Subject: Duke Energy Carolinas, LLC  
William States Lee III Nuclear Station - Docket Nos. 52-018 and 52-019  
AP1000 Combined License Application for the  
William States Lee III Nuclear Station Units 1 and 2  
Response to Request for Additional Information  
(RAI No. 2350)  
Ltr# WLG2010.08-02

**Lee Nuclear Station Response to Request for Additional Information (RAI)**

**RAI Letter No. 067**

**Reference NRC RAI Number(s): RAI 03.07.01-004**

Figure 1 - Base Case Dynamic Profile Location Map

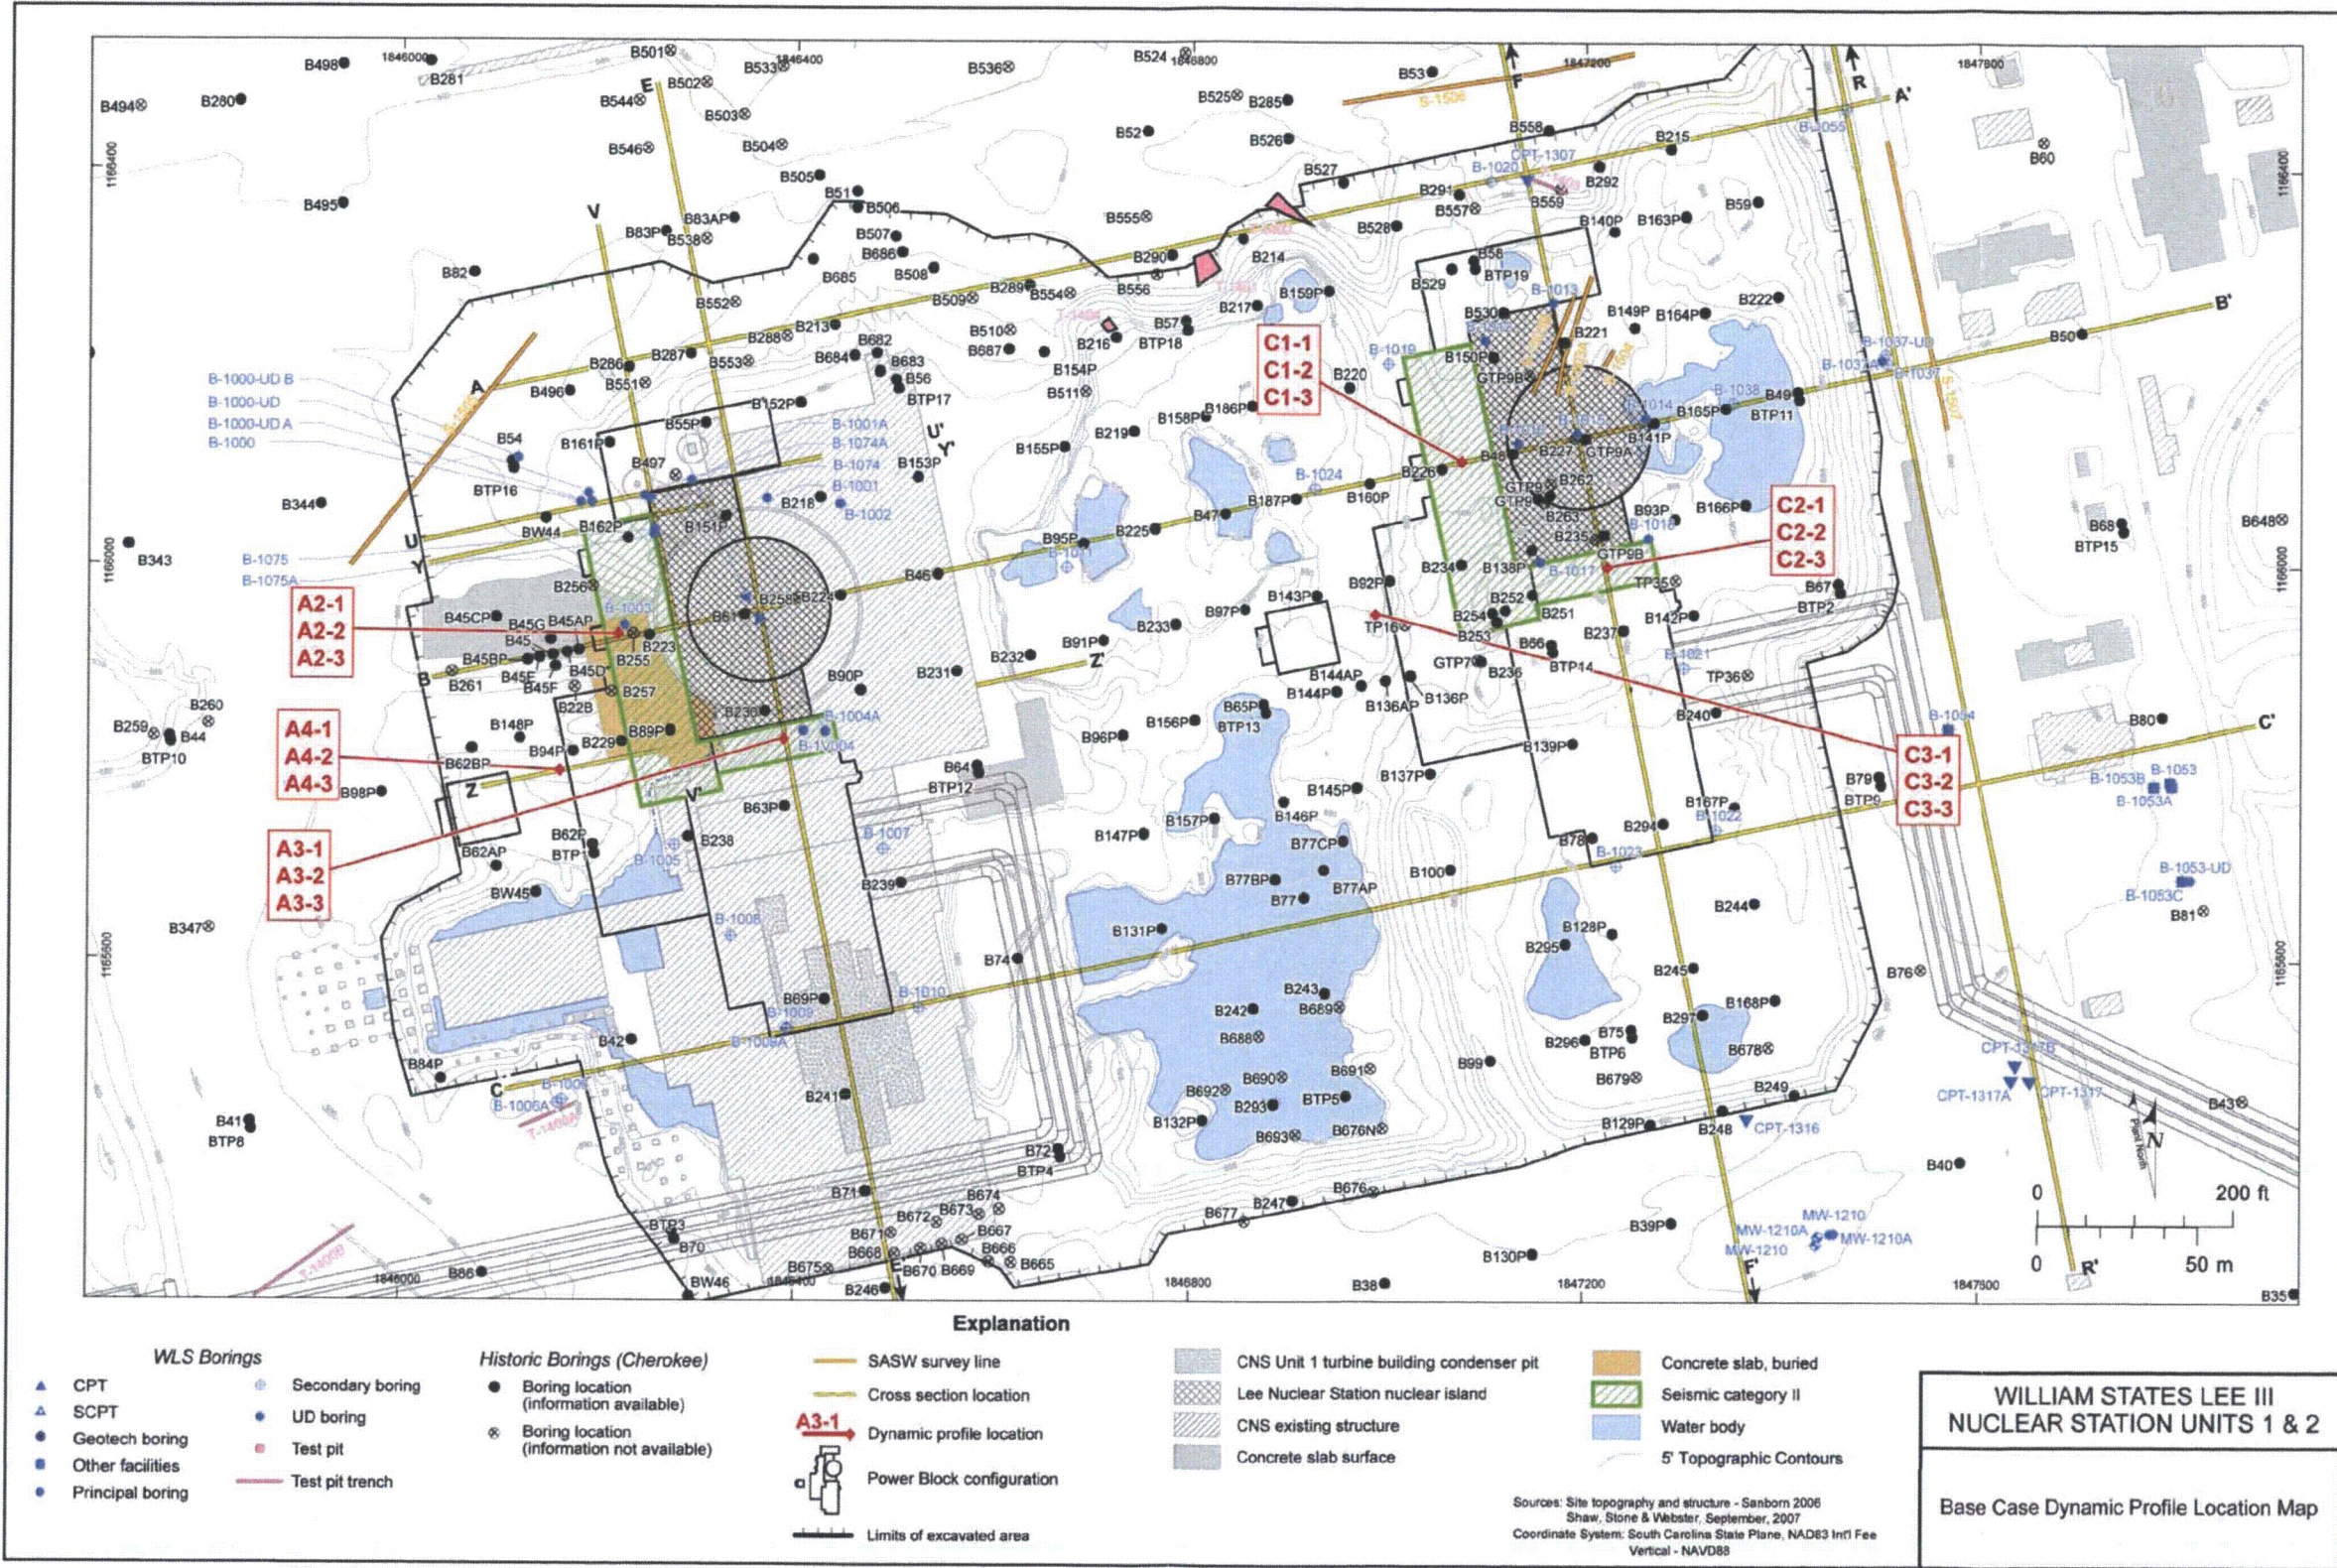
Figure 1 shows these six locations (A2, A3, A4, C1, C2, and C3). Figures 2, 3, and 4 illustrate representative geologic cross-sections, similar to those shown in the FSAR, as well as the location of the profiles selected. Figures 5, 6, 7, 8, 9, and 10 illustrate typical profiles at these six locations for one of the three fill granular materials considered, and for one of the three groundwater levels considered at each location.

Figure 11 - Horizontal Foundation-Level Spectra for SC-II Buildings

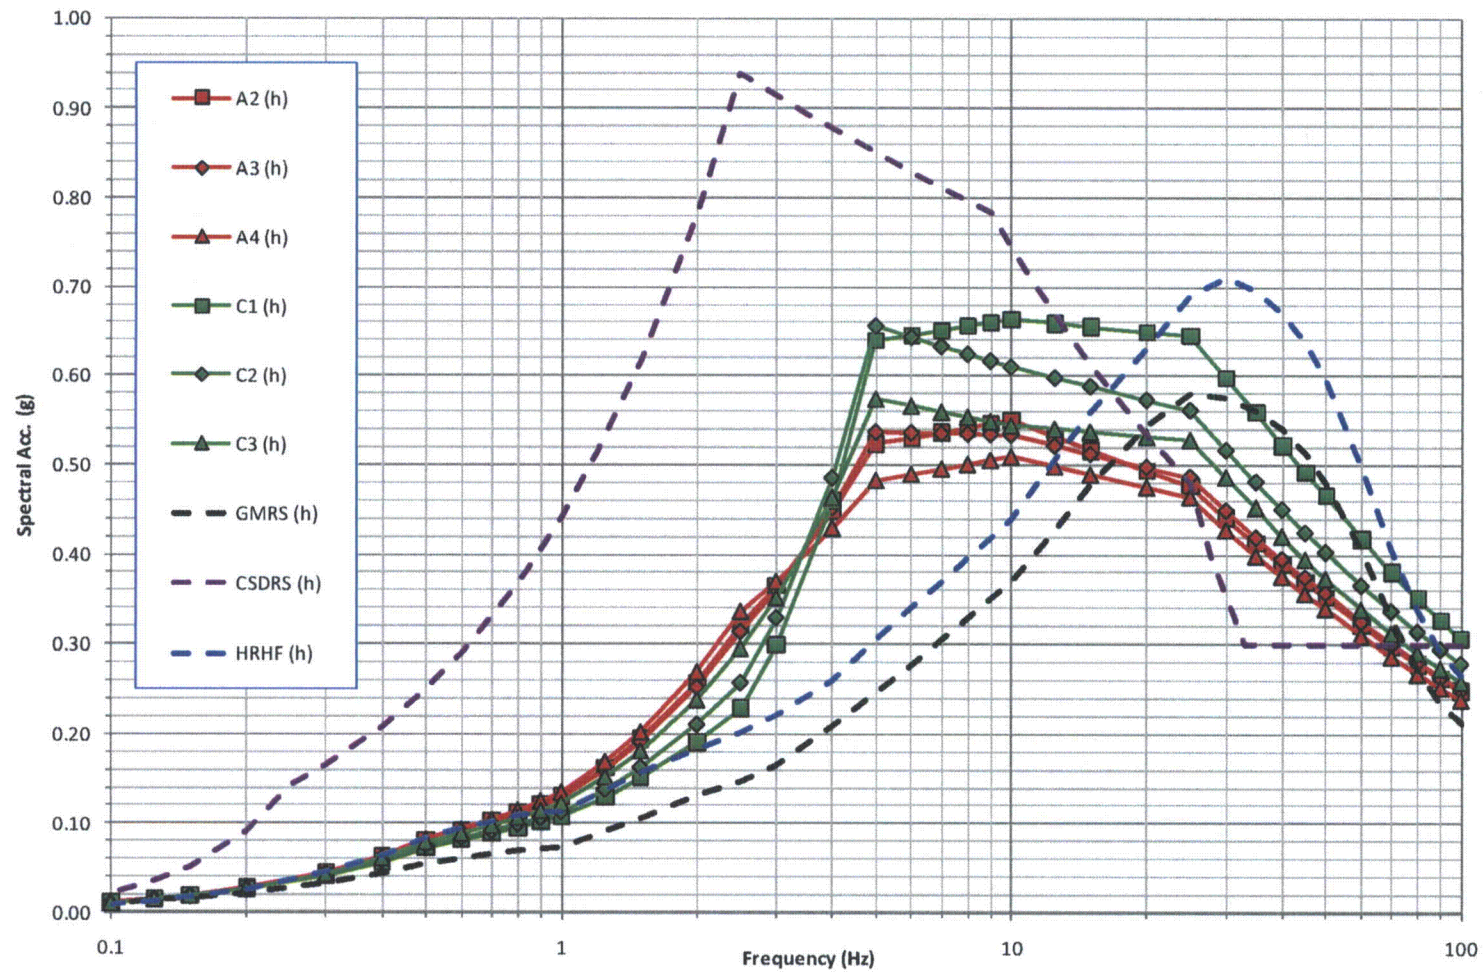
Figure 11 (horizontal) and Figure 12 (vertical) illustrate the resulting foundation-level response spectra for the six locations, and compares these spectra to the site Ground Motion Response Spectra (GMRS), as well as to the generic AP1000 HRHF spectrum and the AP1000 Certified Seismic Design Response Spectra (CSDRS). As anticipated by the RAI, amplification is noted in some frequency ranges compared to the characteristic hard rock spectrum shape because of the soil column above the rock surface.

Location A3, associated with the Unit 1 Turbine Building first bay, and location C3, associated with a Unit 2 general free-field location, are most similar to the AP1000 DCD hard rock configuration that was evaluated for adjacent structures. These two locations have about forty feet of engineered fill below the ground surface, with hard rock (or legacy concrete with high shear wave velocity) below that depth.

Other Unit 1 spectra (locations A2 and A4) are associated with profiles with approximately seven to ten feet more engineered fill over hard rock or legacy concrete. Profiles at location A4 also include the effect of a layer of partially weathered rock beneath the non-seismic portion of the Annex Building. These other Unit 1 profiles result in similar or lower foundation-level accelerations compared to locations A3 and C3.

Unit 2 profiles at locations C1 and C2 are associated with thinner layers of engineered fill (approximately 30'), and result in higher foundation-level accelerations between 5 Hz and 30 Hz. Since the fill properties investigated are consistent between the different locations, this difference in response is attributed to the thinner layers of engineered fill beneath the adjacent structures at those locations.

**Figure 13 - Horizontal Foundation-Level Spectra for SC-II Buildings Compared to Reference 3**

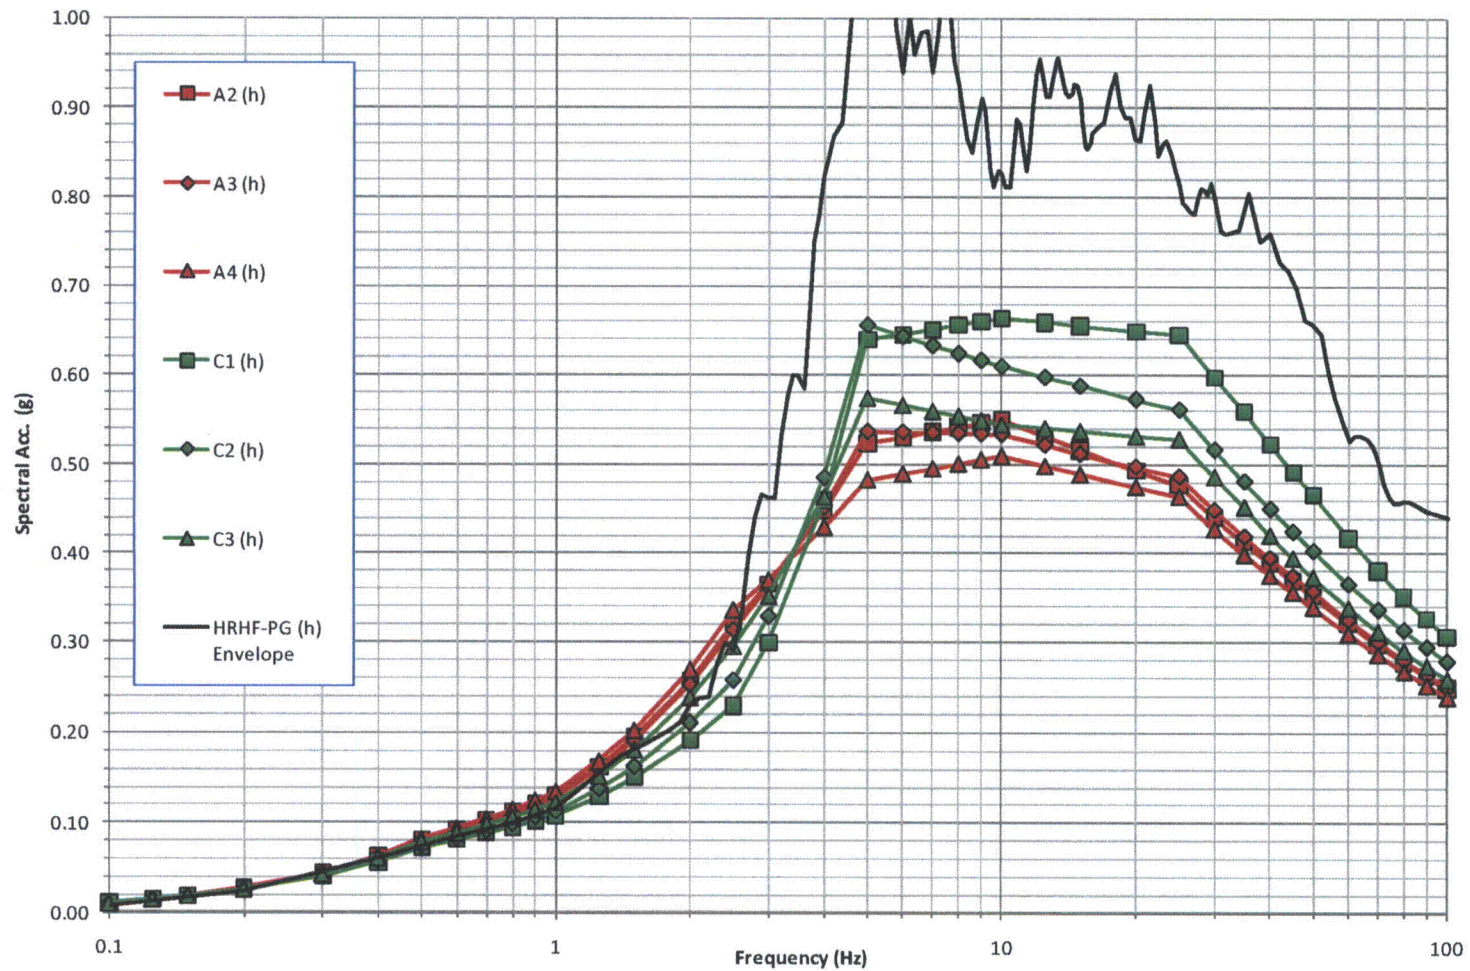
Figure 13 (horizontal) and Figure 14 (vertical) compare the Lee site-specific foundation-level spectra to the envelope of the generic HRHF-PG soil surface spectra used by Westinghouse in Reference 3.

For frequencies above about 2.5 Hz, it is clear that the generic spectra lie above the Lee site-specific demand. Locations A3 and C3, which are closest to the AP1000 DCD HRHF configuration considered, show significant margin between the site demand and the envelope of the HRHF-PG spectra. Other Unit 1 locations A2 and A4, which exhibit larger thicknesses of fill material and greater depths to hard rock, show spectra that are consistent with, or lower than, those for A3 and C3. Consistent with the expectation in the RAI, the Unit 2 profiles at locations C1 and C2, with higher rock surface and corresponding thinner layers of fill material, exhibit more amplification between 5 Hz and 30 Hz. Nevertheless, the spectra for locations C1 and C2 also exhibit significant margin between the Lee site-specific demand and the HRHF-PG spectra considered in setting the design criteria for Seismic Category II adjacent buildings.

For frequencies below 2.5 Hz, the foundation-level spectra for almost all the Lee site-specific locations exhibit minor exceedances above the HRHF-PG spectra. In this frequency range, the HRHF-PG and Lee site-specific demands are dwarfed by the requirement to also design adjacent structures for the CSDRS. This is illustrated in Figures RAI-SRP3.7.1-SEB1-15-23 through RAI-SRP3.7.1-SEB1-15-26 of Reference 3, where the relative contribution of HRHF-PG inputs and that of other design conditions can be seen in terms of their effect on the envelope design criteria for the adjacent buildings.

Figure 15 - Lee Unit 1 - Northwest Corner Dynamic Profile Location Map

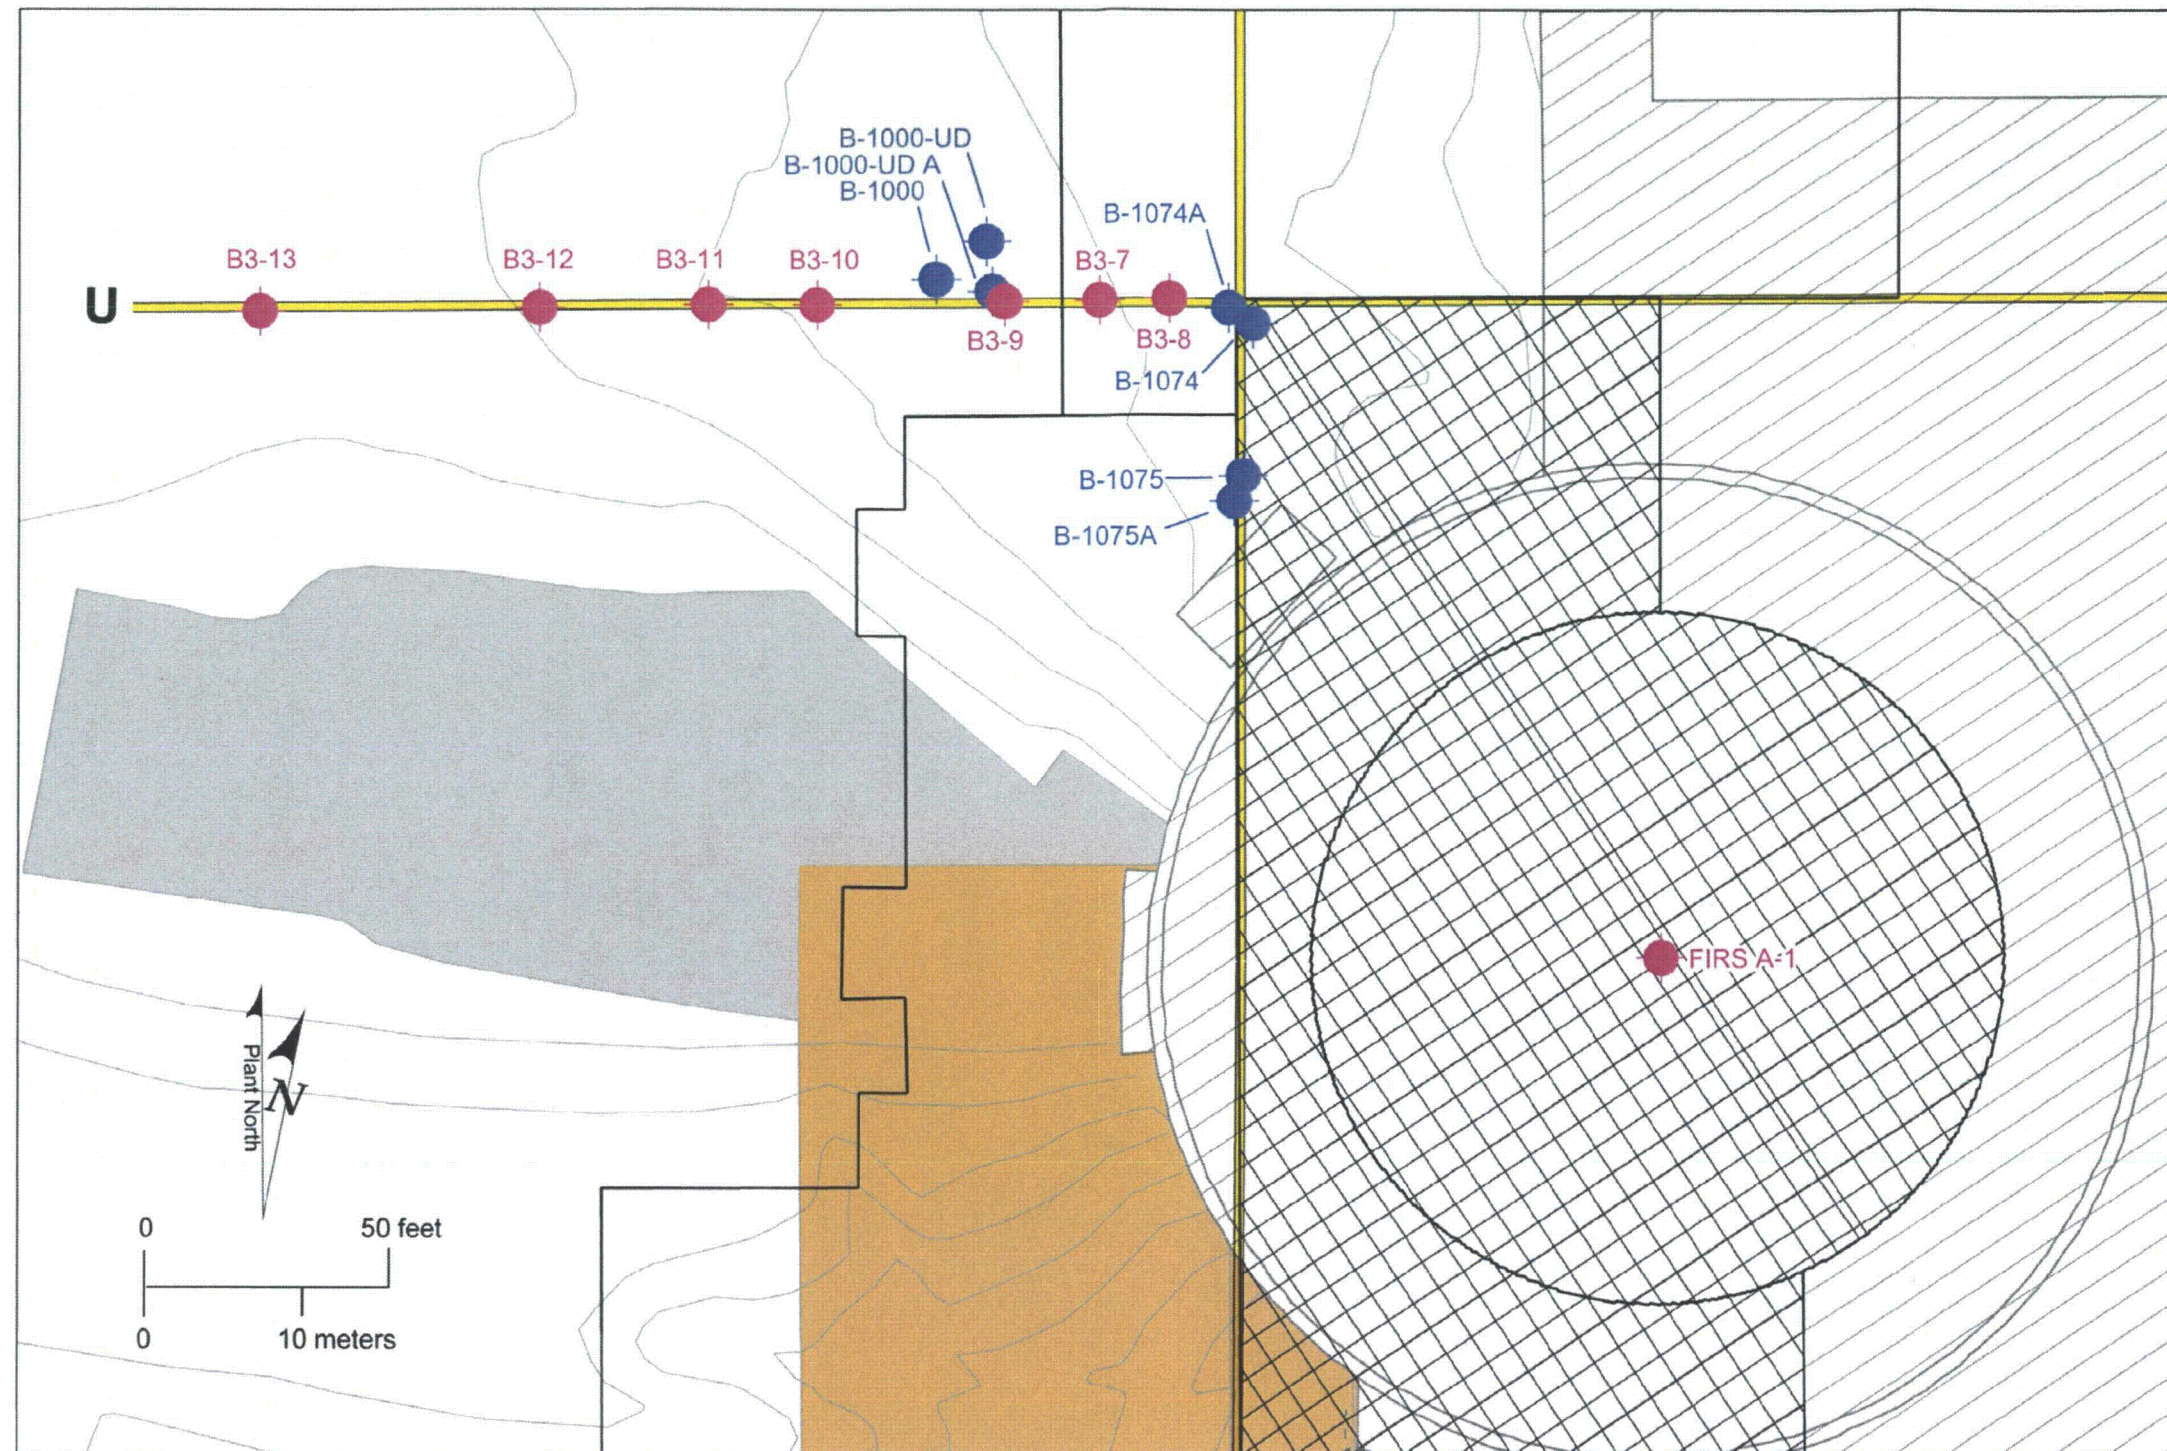
To ensure that the support conditions at the northernmost end of the Unit 1 Annex Building (Northwest Corner) do not result in unacceptable amplification of motions in that area, Duke Energy has also evaluated several profiles in that area. Figure 15 shows the location of these profiles, and Figure 16 illustrates the associated geologic cross-section, similar to that shown in FSAR Figure 2.5.4-245, and the location of the profiles. Profiles at locations B3-7, B3-8, and B3-9 are representative of the northern portion of the Unit 1 Annex Building support zone. These profiles are characterized by thicker layers of granular fill material than those investigated above, ranging from fifty to seventy feet thick. Figures 17, 18, and 19 illustrate typical profiles at these locations for one of the three granular fill materials considered and for one of the three groundwater levels considered at each location. Other profiles include features such as saprolite fill and Group I fill that are not characteristic of the material supporting the Annex Building.
